# Transport Canada Navigational Study of the Lower Athabasca River – Outcomes and Technical Review

Dr. Martin Carver, PEng/PGeo, PAg, (BC) PGeo (AB) AEA Project #404-21 February 4, 2020

# Aqua Environmental Associates

Figure 1. 35 sites from Golder (2018). (reproduced from Golder 2018, p5).

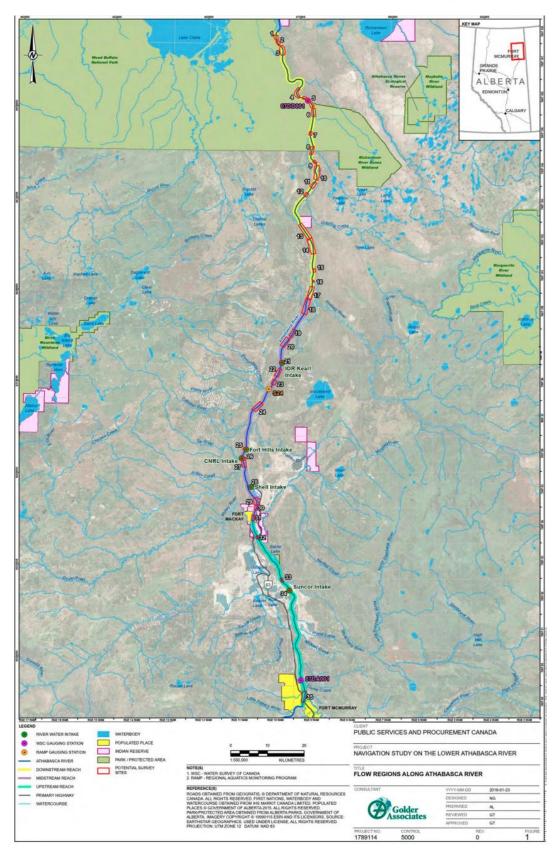
A central output of Golder (2018) is a compilation of field information provided by Indigenous community members identifying the location, degree and extent of navigational concerns. Covering a total of 35 locations, sites of concern are shown spatially in Figure 1. Golder (2018) also summarizes navigability information, hydrometric data, oilsands water withdrawals and climate projections. Although the navigability criteria presented in Golder (2018) have serious shortcomings (see section 2.3.3), it appears that these have largely not been repeated in Dillon (2019) and have not compromised the outcomes of the overall study.

# Figure 2. Mean water-level reduction across Dillon's 11 surveyed sites due to water withdrawals of 4, 8, 16, 20 and 29 m<sup>3</sup>/s for the full range of river discharges ranging from 200 m<sup>3</sup>/s to 1600 m<sup>3</sup>/s.

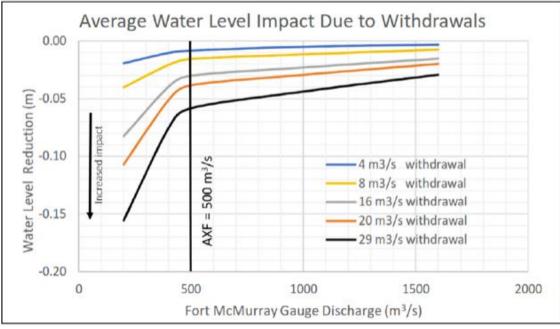
Using the survey information and rating curves for each of its field sites, Dillon (2019) generates a plot (Figure 8, p23) that shows that across its survey sites, water depth declines more rapidly below a value of  $Q_{FM}$  of 500 m<sup>3</sup>/s. See Figure 2. This accelerated loss in water depth just below the AXF means that the effect of water withdrawals increases more rapidly under these low river discharges. For example, the water level impact of 29 m<sup>3</sup>/s withdrawal rate increases to 250% of this value under more extreme low discharges. This echoes the finding provided by MCFN to the Joint Review Panel for the proposed Teck Frontier Mine (Carver 2018a), underscoring its validity.
